RE: 1517 N Street, The Warren – 118 Apartment Units – REQUEST FOR ASSISTANCE

Arborist Comments

Project Name: East End Gateway Site 1

RE: Arborist Report: The Warren

SITE PLAN

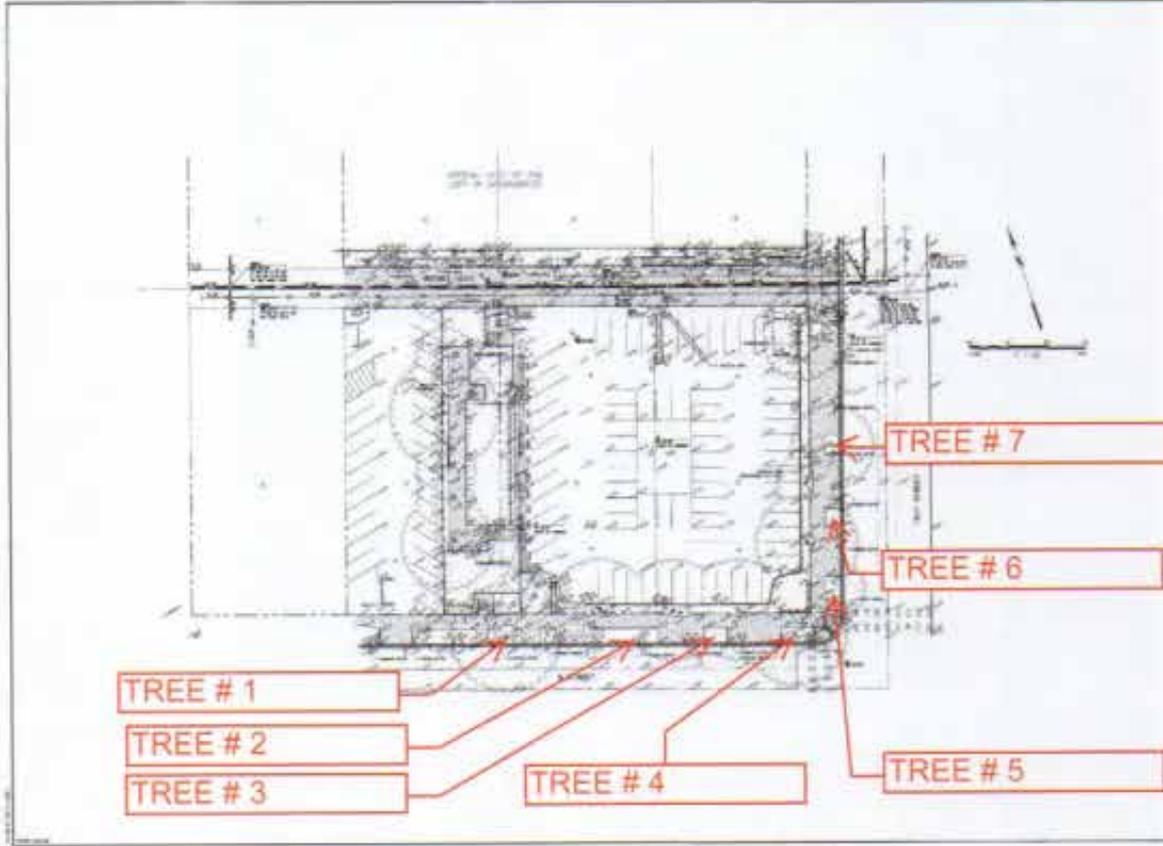
- Existing street trees shown on the site plan + landscaping plan are not a site suitable species given the canopy space limitations created by the proposed building walls.

- Unless revisions are made to provide greater canopy space for future growth, the existing trees must be removed. The park strip in the City right of way can then be replanted with a more site appropriate species and spacing.

- (N Street) If the building design is not revised to provide greater tree canopy space, revise plan to show seven semi columnar species trees at a spacing of 30' in the park strip planter along N Street. Three existing Chinese Pistache (*Pistacia chinensis*) trees along N Street are shown planted 80' and 60' apart, (City standard spacing for this species is 40'). The existing Pistache trees are approximately one third to one half of their mature size. This species typically develops a wide spreading canopy with a radius of 25' to 30' at maturity. The proposed building will only allow a canopy radius of 15' to 16'.

- (16th Street) Revise plan to show an 8' x 15' minimum planter opening for each tree along 16th Street. Tree spacing shown along 16th Street is approximately 35', the available tree canopy radius with the proposed building wall is 15' to 16'. Generally columnar and semi columnar trees are planted in the City right of way at a spacing of 20' to 25'. This would allow 10 trees to be planted along 16th Street where 7 trees are shown on the proposed plan. The 35' tree spacing can remain pending UFS species selection approval.

- Show seven semi columnar species trees planted 30' apart along N Street at midpoint between carriage path crossings in 20' x 8' planters. Choose one of the following trees for planting along N Street:

16&N WARREN BUILDING
 TREE SHORING
 5/21/14 CONCEPT

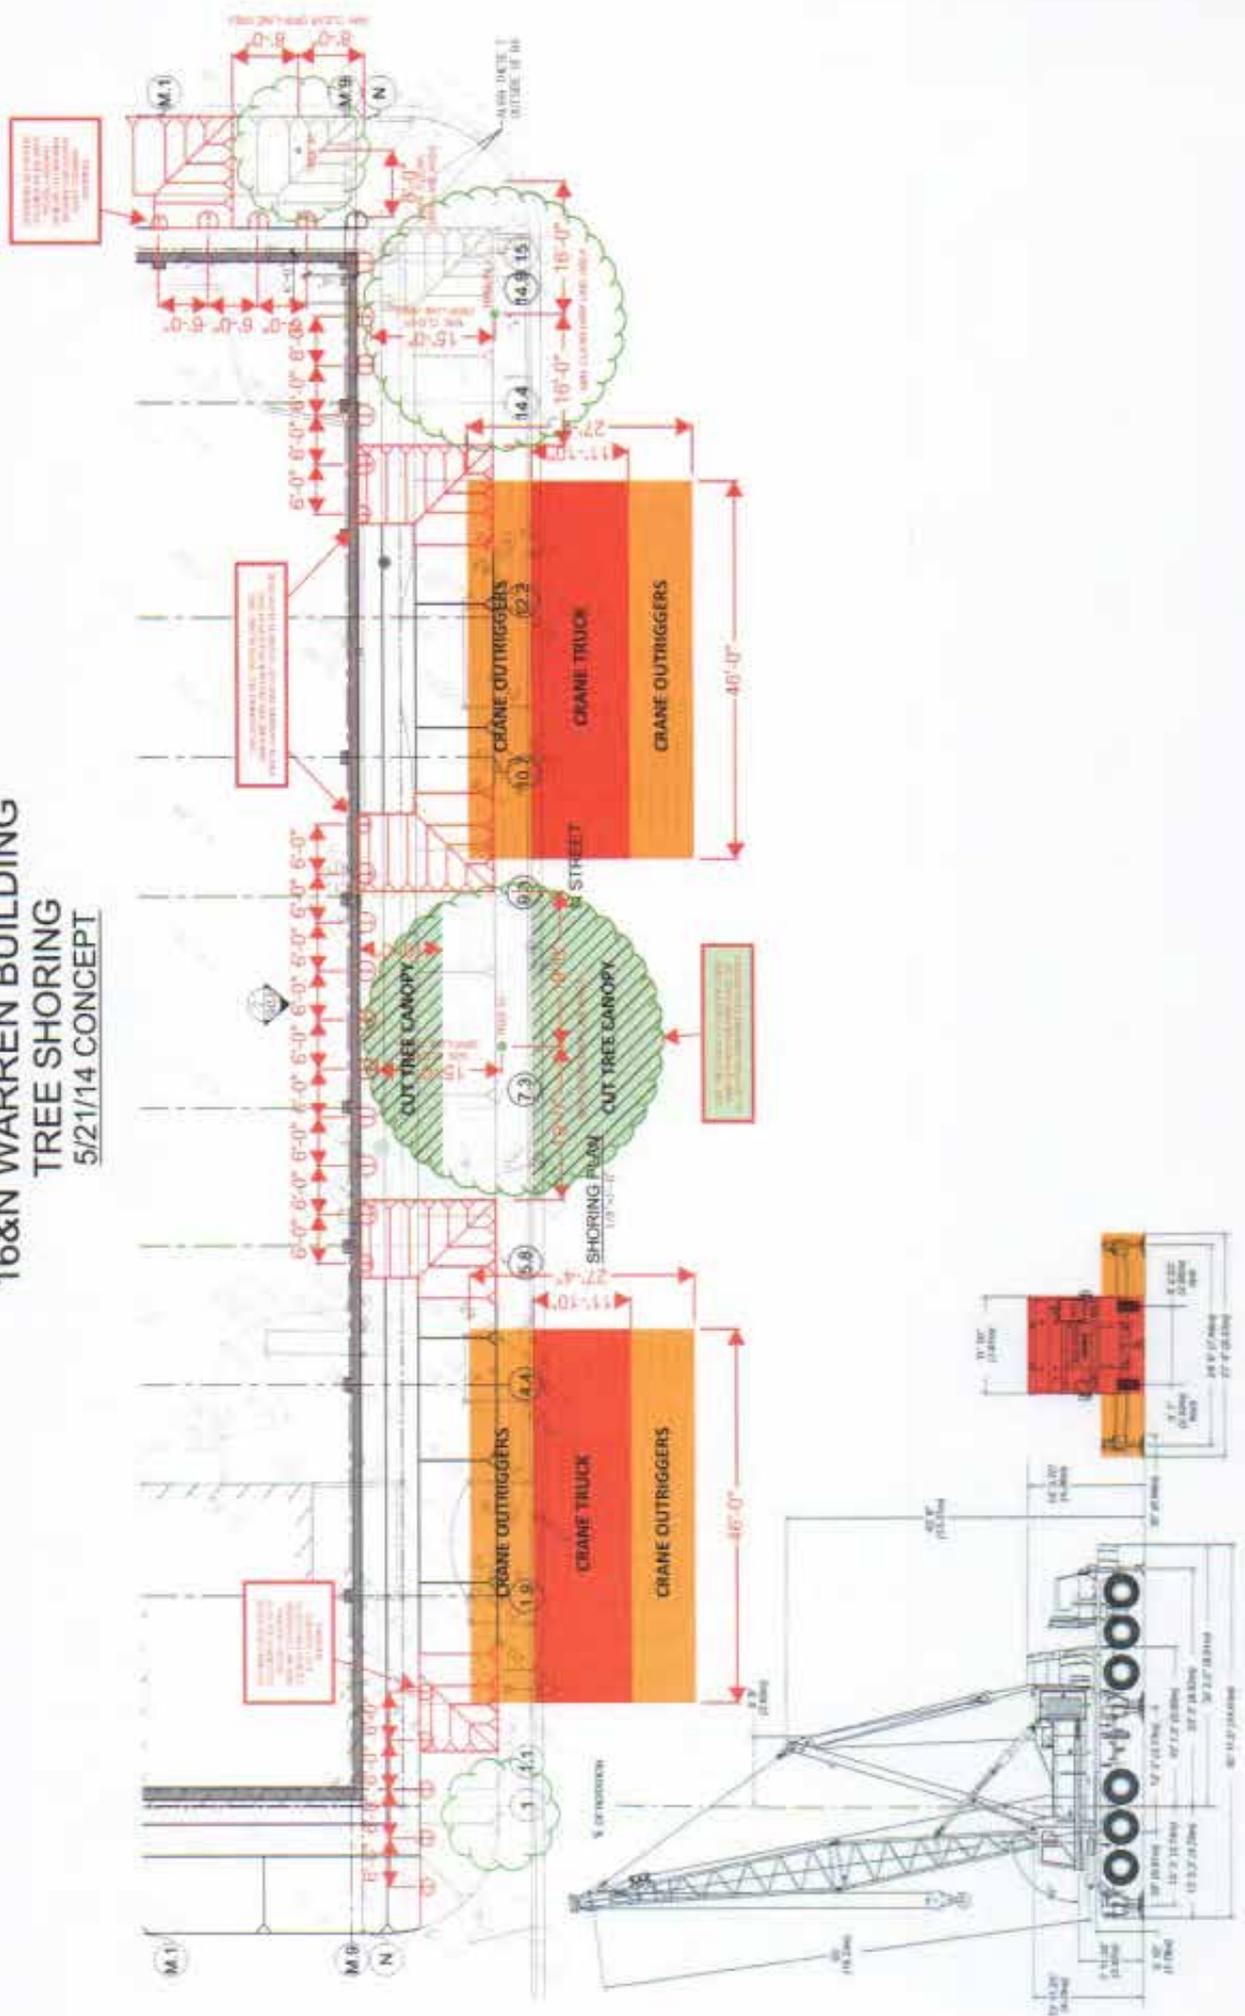
- Condo residences are to be constructed which will require the installation of shoring on three sides of the trees to be preserved; shoring at TPZ and 15' to north for trees #2 and 4 and at TPZ for tree #5 (see figure below);
- A stormwater retention planter is proposed along N Street 13 feet to the east and 9 feet to the west of tree #2;
- The sidewalk, curb and gutter are to be replaced along N and 16th streets; and
- The canopy of Tree #2 would need to be pruned at the curb line and 10 feet from the building to accommodate the crane which is to install building modules; this would remove the majority of the canopy of the tree.

Assuming the stormwater retention planter was moved outside of the TPZ of Tree #2, the impact of the construction would be low/moderate (scale of low to high). However, the severe pruning necessary to accommodate the crane, would drastically compromise this tree's aesthetics, structure and possibly lead to sunburn. For these reasons, I would recommend the tree be removed. The impact of the proposed construction, assuming the tree preservation guidelines below are followed, would be low/moderate for trees #4 and 5.

- Install shoring as shown in 5/21/14 concept plan above.
- Install stormwater planters outside of TPZ's.
- Sidewalk, curb and gutter should be installed on grade with no scarification of native soil.
- Avoid utilities within TPZ's.
- Install irrigation within planters to uniformly wet soil.
 - Irrigation lines should be dug at edge of TPZ or by utilizing compressed air/water as approved by Consulting Arborist to avoid significant root injury.
